# Access Compliance Report

## Public Rights-of-Way

### (Curb Ramps)

Intersection ID: 48570	Main Street: MATLEA_CT	Cross Street: RED_SQUIRREL_TL	Location: N
ADA ID: 3AA3A883851C	Ramp Type: PerpDiag	Initial Pass/Fail: Fail	Overall Compliance: No
Severity Score: 8.75			
Codes/Mitigation Info/Possible Solution		Field Measurements/Component Compliance

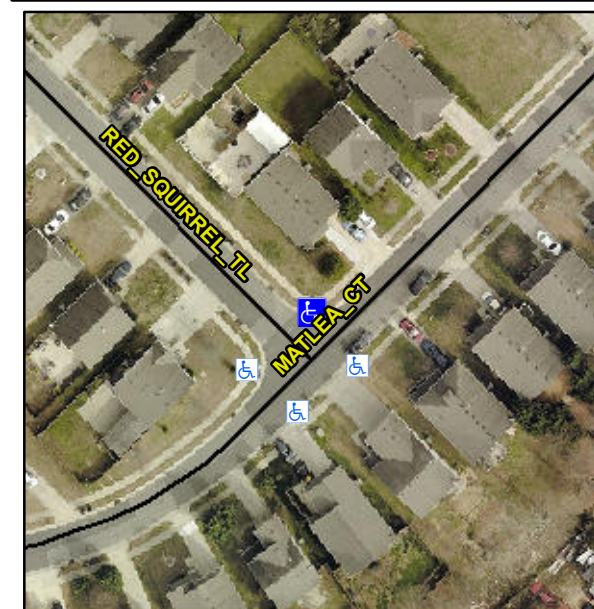
**Not Found, R304.5.1**

**Remove & Replace Curb Ramp With Two New Directional Ramps or Equivalent.**
